LIVERPOOL RANGE WIND FARM

Amendment Report

Report No. 23141/R02

Date: August 2023

Figure 1.4 Proposed Amendments to the Mod-1 Project Infrastructure Layout

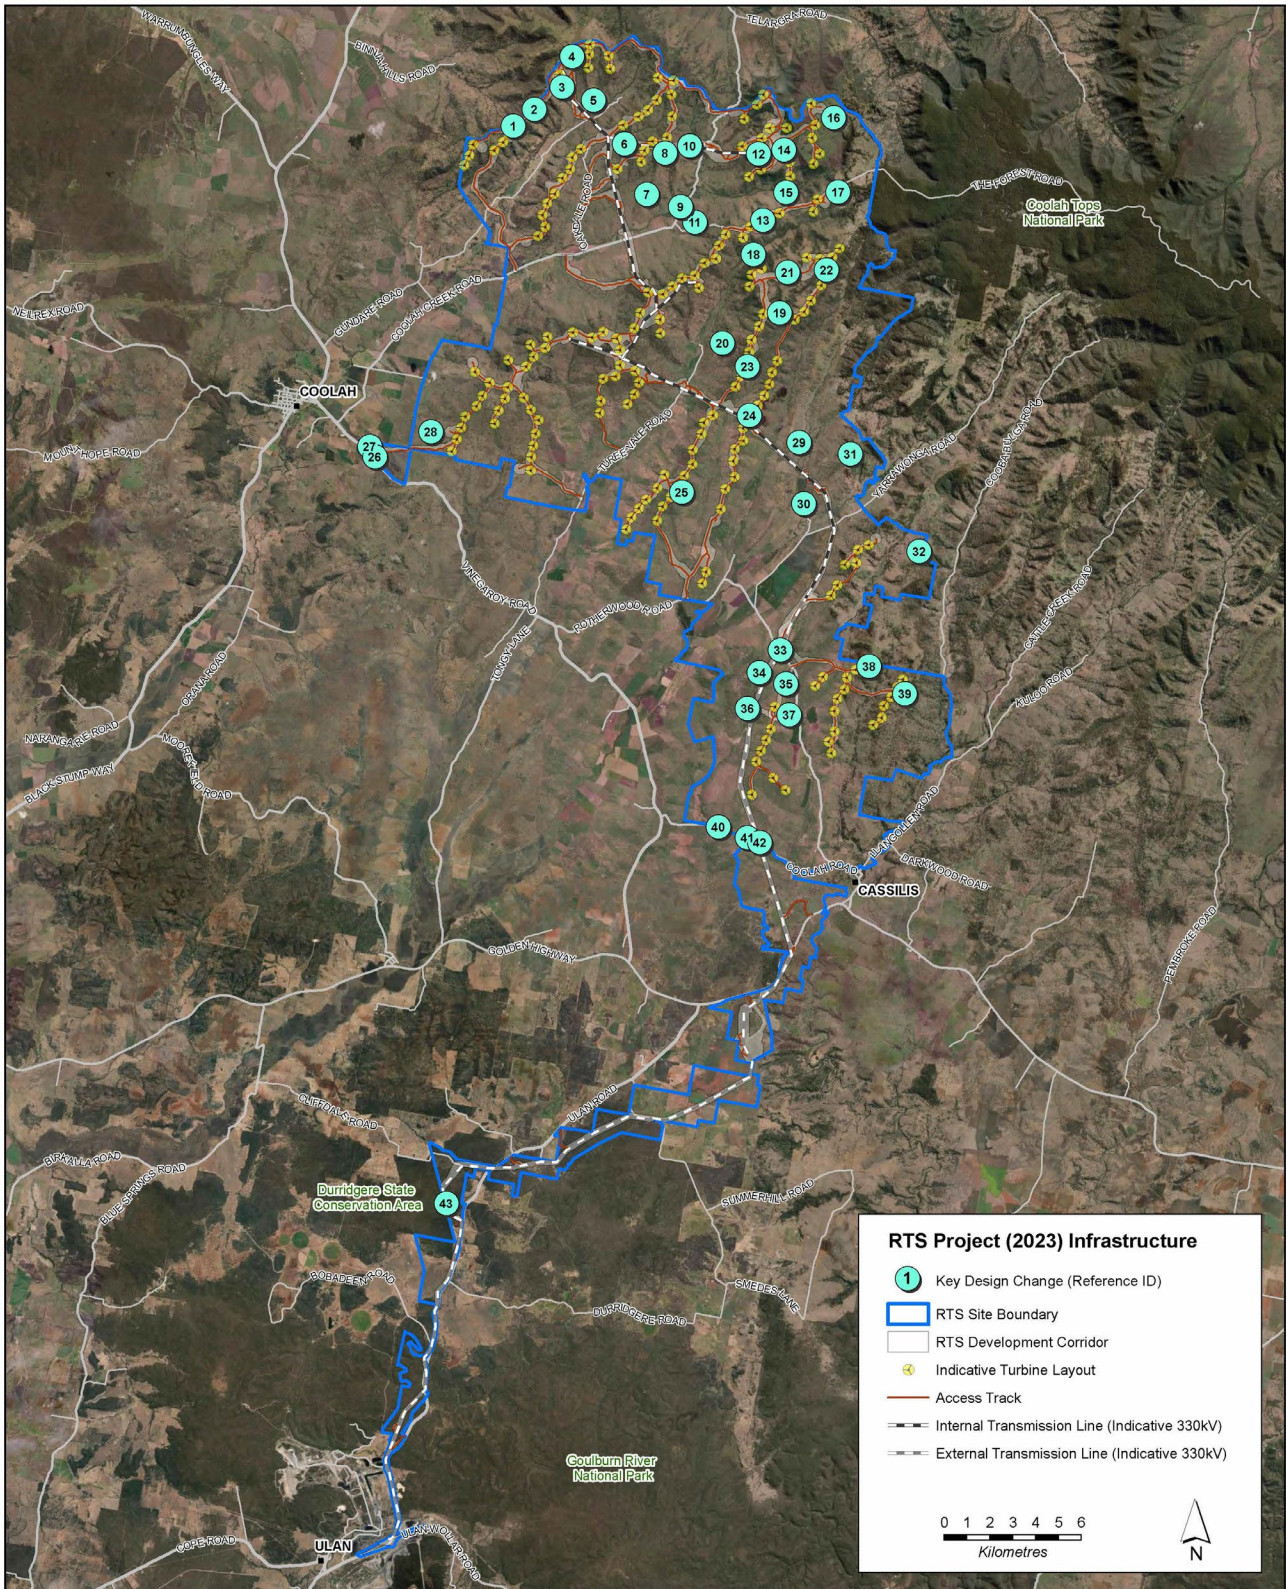
A summary of the key proposed amendments to the Mod-1 Project are provided in **Table 1.1**, with an overview map provided in **Figure 1.4** below. The proposed amendments are described in detail in **Section 3.0**.

31	Removal of three turbines (F18, F23 and F27) and associated infrastructure to avoid impacts to higher quality Box Gum Woodland CEEC.
32	Removal of four turbines (F36, F39, F40 and F41) and associated infrastructure to avoid impacts to higher quality Box Gum Woodland CEEC.
33	Realignment of overhead 330 kV transmission line to avoid intact patch of treed vegetation and increase separation distance from nearby residence (F8-1).
34	Realignment of optional overhead 330 kV transmission line to minimise impact to intact treed vegetation and increase separation distance from nearby residence (F8-1).
35	Realignment of underground 33 kV reticulation cabling from turbine F07 in a more direct route towards Substation F.
36	Removal of underground 33 kV reticulation cabling as alignment now follows a more direct route between turbine F07 and Substation F.
37	Realignment of access track from Rotherwood Road to utilise existing access track and minimise ground disturbance.

38	Removal of two turbines (E19 and F29) to minimise impacts to Box Gum Woodland CEEC.
39	Removal of two turbines (F37 and F38) and associated infrastructure to avoid impacts to higher quality Box Gum Woodland CEEC.
40	Removal of use of Coolah Road by all vehicles (light, heavy and OSOM) as a result of removal of duplicate site access points. Access will instead be provided from Rotherwood Road.
41	Removal of duplicate site access point and access track from Coolah Road.
42	Removal of larger areas of mapped Box Gum Woodland CEEC from the Modified Development Corridor (both within the wind farm and along external transmission line) wherever practicable to avoid potential impacts.
43	Removal of optional external 330 kV transmission line alignment to avoid impacts to Durrigere State Conservation Area in this location.

Figure 3.3 Amendments to Project Site Boundary

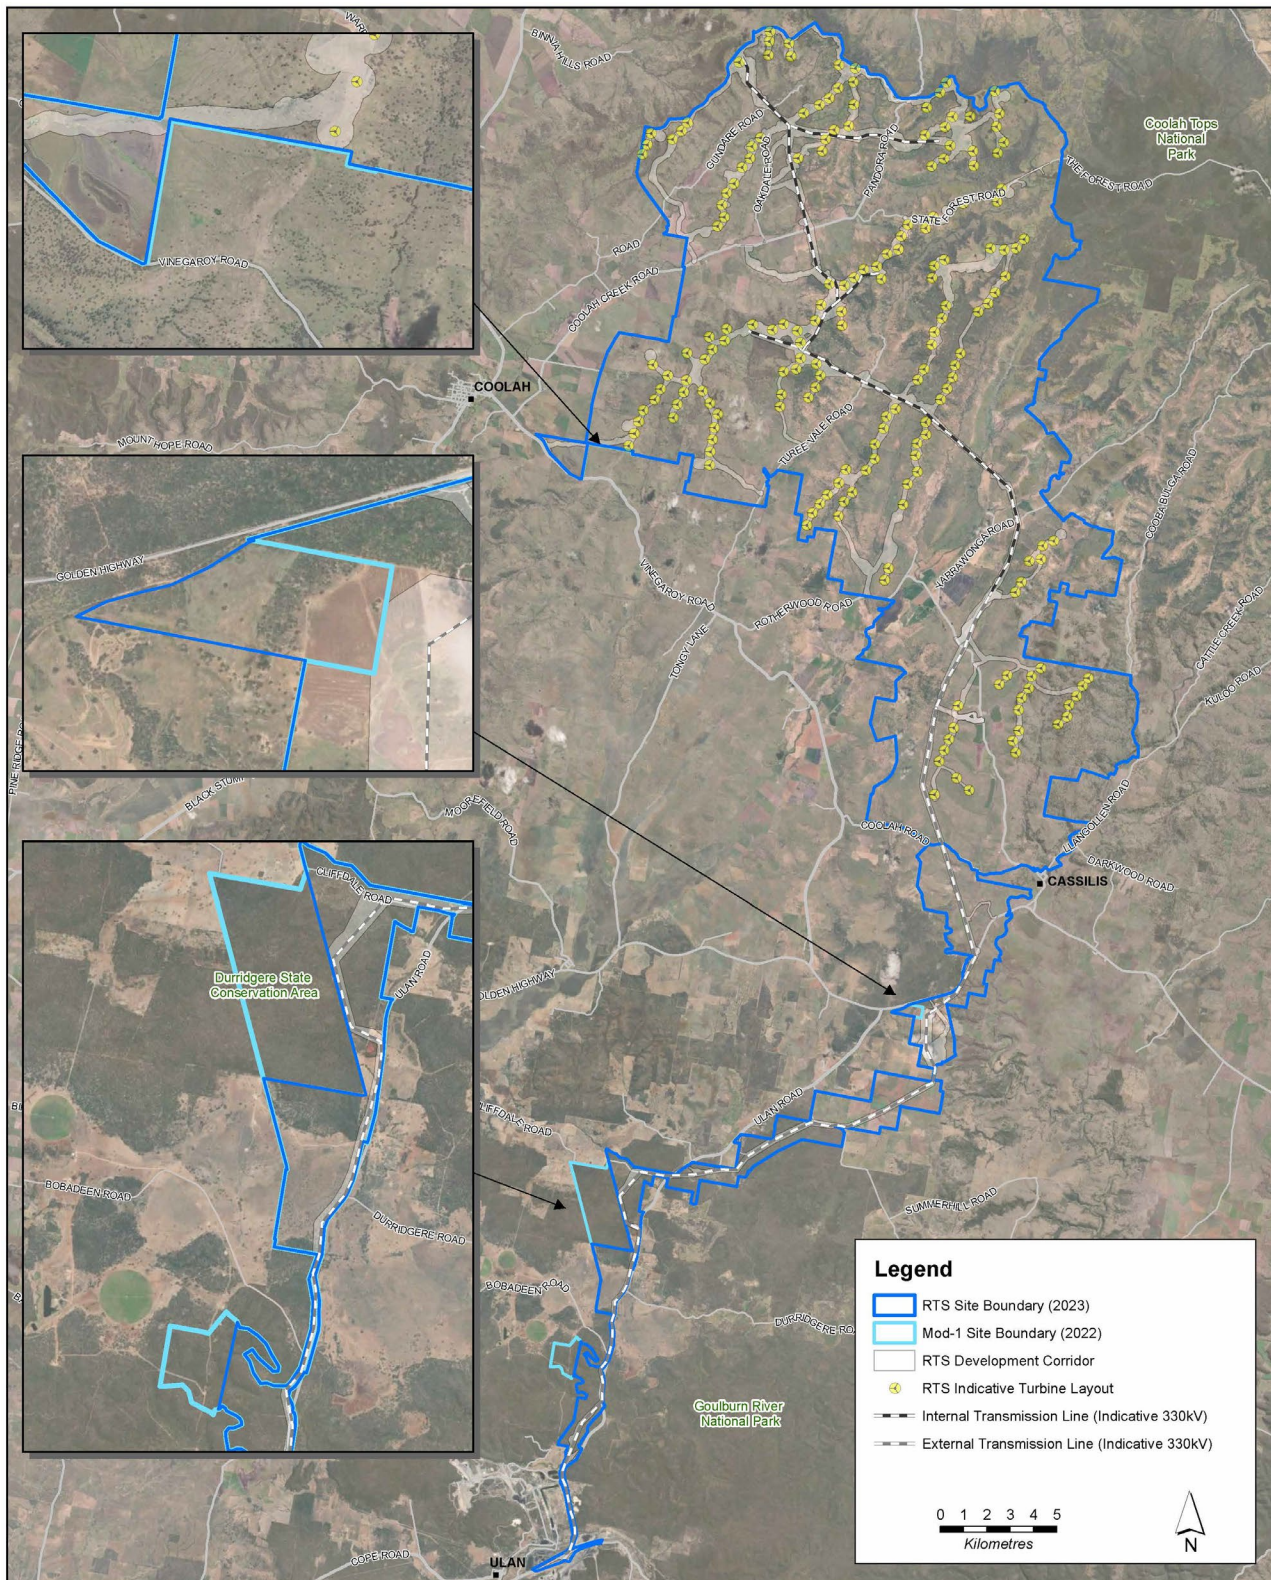
The overall site boundary, incorporating the wind farm and external transmission line, has been reduced by 734 ha (-1%) when compared to the Mod-1 Project. This comprises a 7 ha reduction to the wind farm site boundary and a 727 ha reduction of the external transmission line site boundary. The two key changes to the site boundary are shown on **Figure 3.3** and described below:

Figure 3.6 Comparison between Mod-1 Project Turbine Layout and RTS Project Turbine Layout

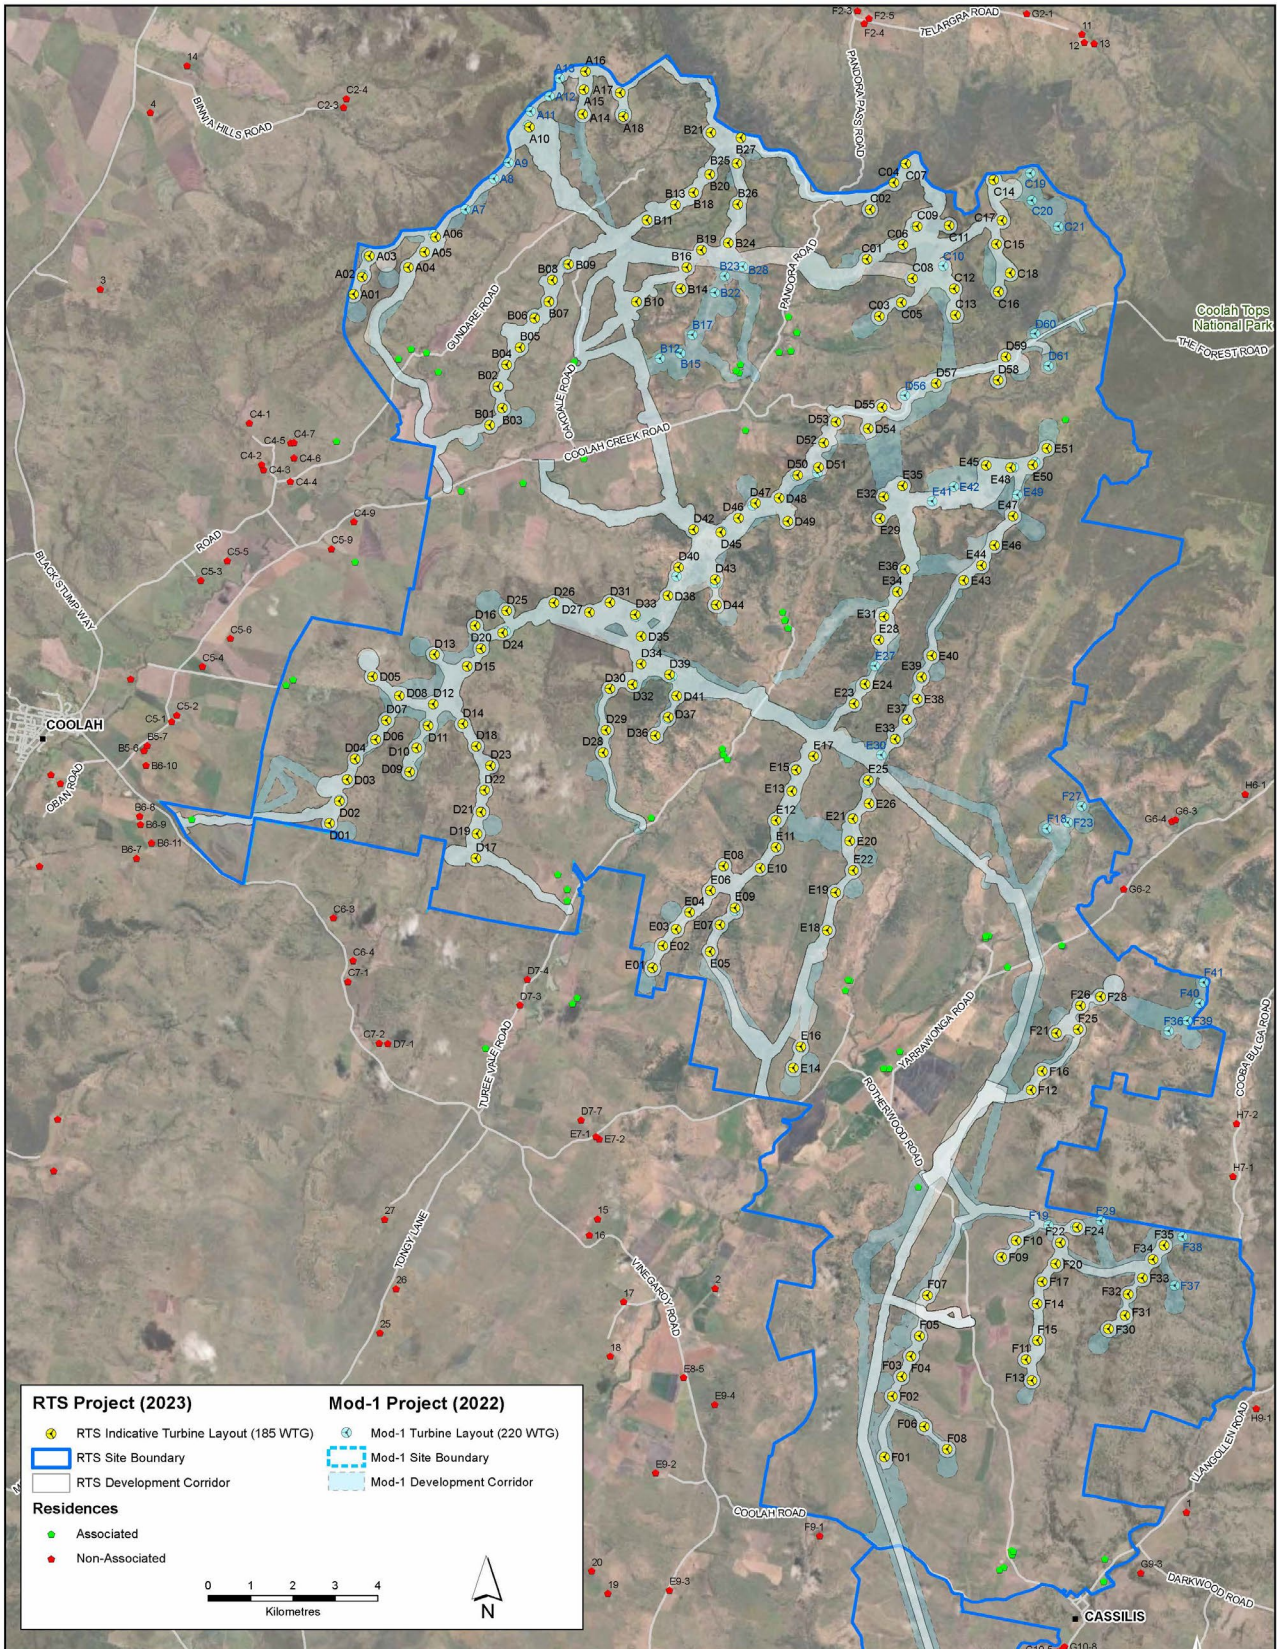
Turbine ID No.	Reason for Removal/Relocation
A7, A8, A9, A11, A12, A13, B22, B23, B28, C10, D56, E30, E41, E42, and E49	Removed to minimise ground disturbance and impacts to native vegetation.
B12, B15 and B17, E19, E27, F18, F23, F27, F29 F36, F37, F38 F39, F40 and F41	Removed to minimise ground disturbance and avoid impacts to Box Gum Woodland CEEC.
C19, C20, C21, D60, D61	Removed to reduce visibility from Pinnacle Lookout, reduce potential turbine noise impacts within Coolah Tops National Park, avoid impacts to a sensitive area of cultural heritage, and avoid impacts to native vegetation.
D40, D43 and E31	Relocated to avoid impact to NSW Telco’s proposed communication link across the Project site.

Overall, the number of turbines has been reduced by 35 when compared to the Mod-1 Project. The RTS Project turbine layout is shown in **Figure 3.1**. A comparison of the Mod-1 Project turbine layout with the RTS Project turbine layout is provided in **Figure 3.6**.

Figure 3.7 Comparison between Mod-1 Project and RTS Project Ancillary Infrastructure Layout

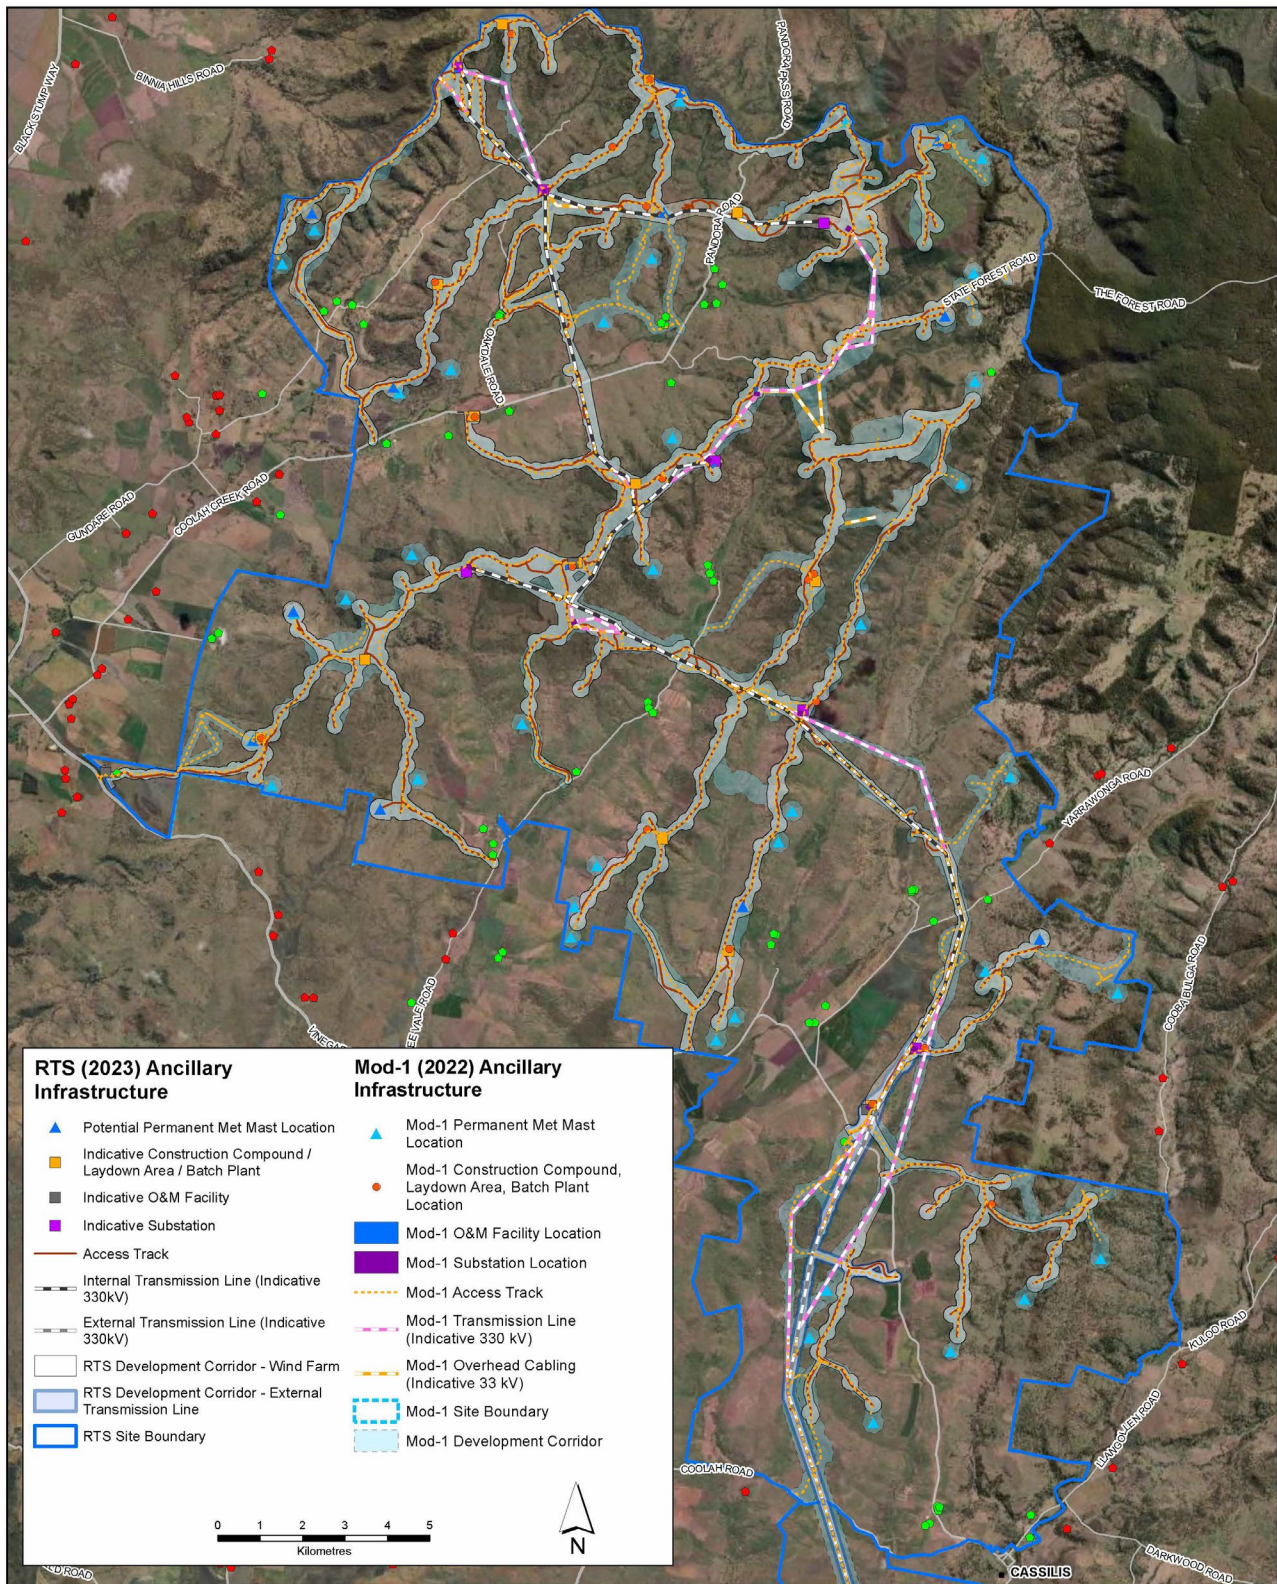
The maximum number of permanent meteorological masts has been reduced by four, down to a maximum of 10. The three O&M facilities remain the same at three indicative locations. The locations of the ancillary infrastructure proposed by the RTS Project is shown in **Figure 3.1** and **Figure 3.2**. A comparison of the ancillary infrastructure between the Mod-1 Project and RTS Project is shown in **Figure 3.7**, noting that the only key change to the external transmission line is a minor realignment to avoid impacts to a section of Durridgere State Conservation Area.

There is no change to the number of temporary concrete batch plants and construction laydown areas (up to nine within the wind farm and one along the external transmission line) required for the RTS Project. The number of indicative locations of these facilities has been reduced (from 18 down to 13 within the wind farm and no change along the external transmission line).
